Montagehinweis für PTFE-Membranen DN 80 - Code 52, 56 bzw. 59

Mounting instruction for PTFE diaphragms DN 80 - code 52, 56 resp. 59

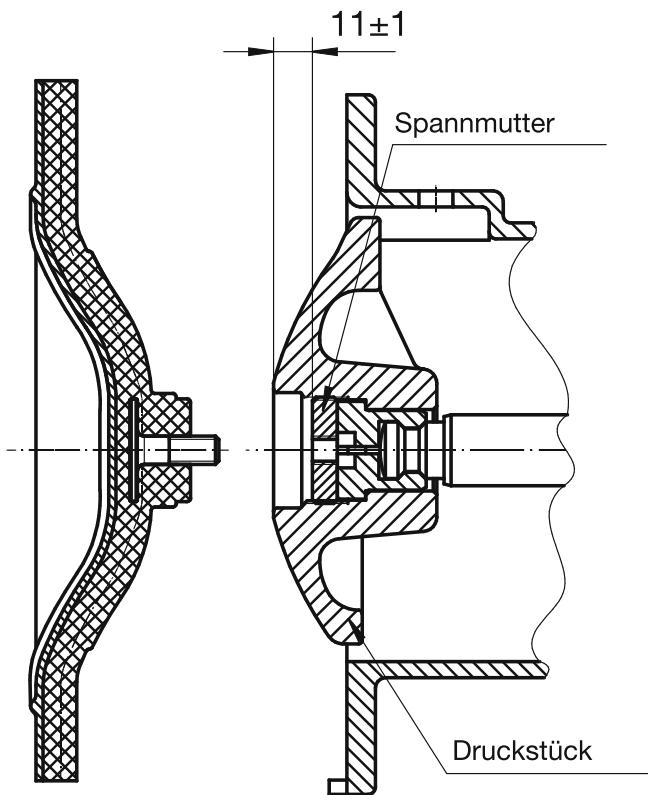
Auf Grund von konstruktiven Änderungen bei o.g. Membranen ist beim Austausch darauf zu achten, dass eine Spannmutter entsprechend dem neuen Funktionsmaß verwendet wird. Zu Kontrolle messen Sie bitte das Tiefenmaß (siehe Bild). Dieses muss 11 ± 1 mm von der Unterkante des Druckstücks bis zur Aussparung des Membrandoms sein. Bei einer Maßabweichung muss die Spannmutter ausgewechselt werden. Diese ist separat zu bestellen (Artikel-Nummer 6216).

Due to constructive alterations of the above mentioned diaphragms please make sure to use an adjustable insert in accordance with the new functional dimensions. Please measure the depth dimension to make sure (see drawing). It must be $11 \text{ mm} \pm 1 \text{ mm}$ from the lower edge of the compressor to the recess in the diaphragm boss. If this dimension is different, the adjustable insert must be replaced. This adjustable insert has to be ordered separately (article number 6216).
